## Revisions to the Text of the Initial Study

The following section contains text revisions to the *Topgolf @ Terra Project Initial Study*, dated September 2016.

FIGURE 2.0-2

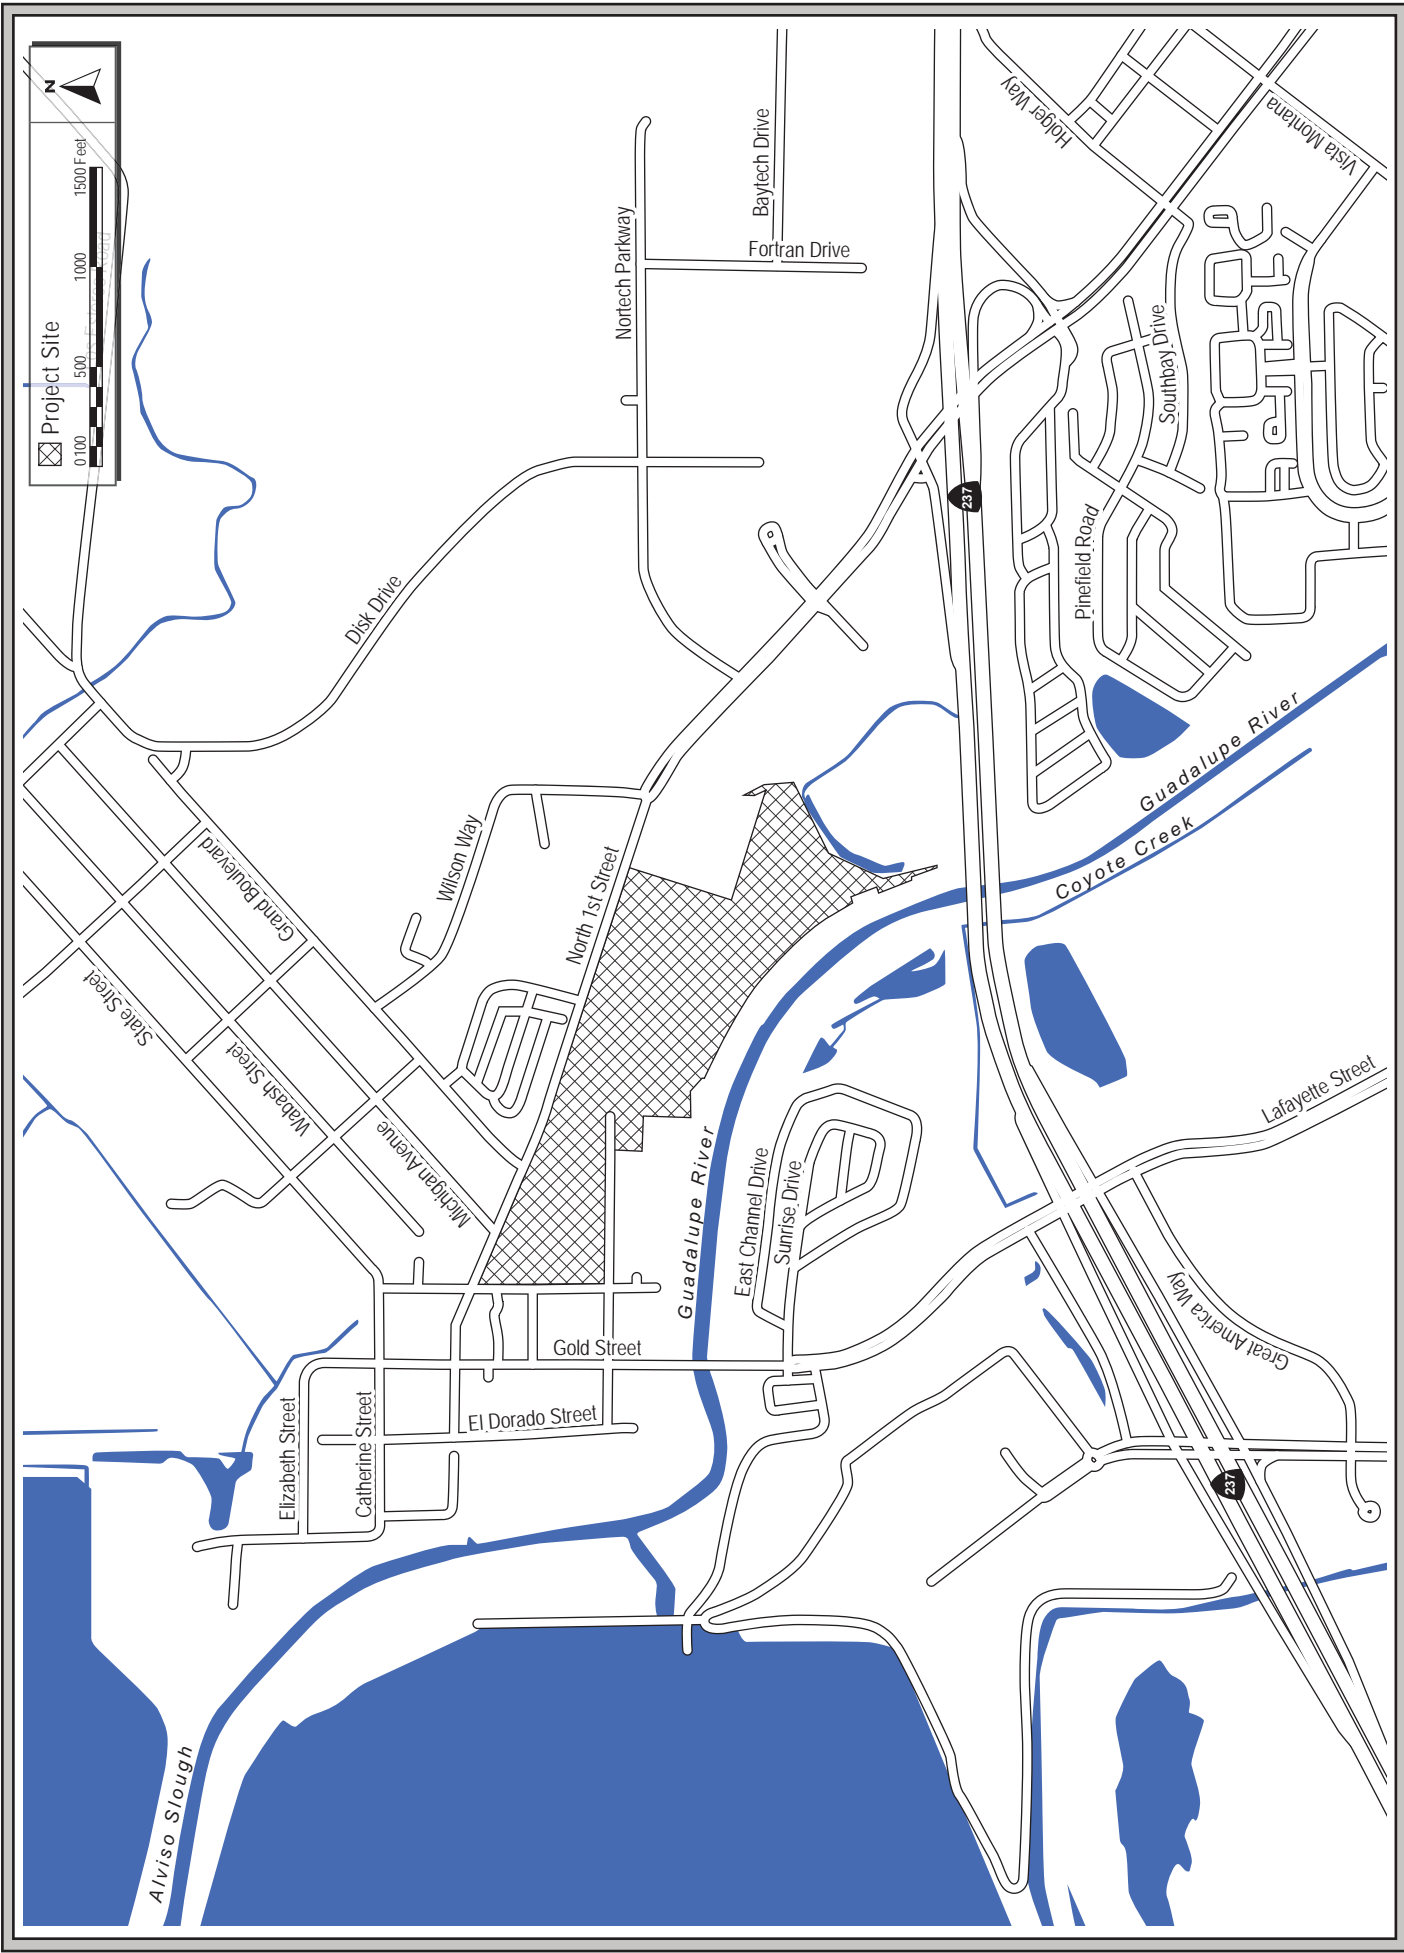
Page 5: **REPLACE** *Figure 2.0-2* with the attached revised figure.
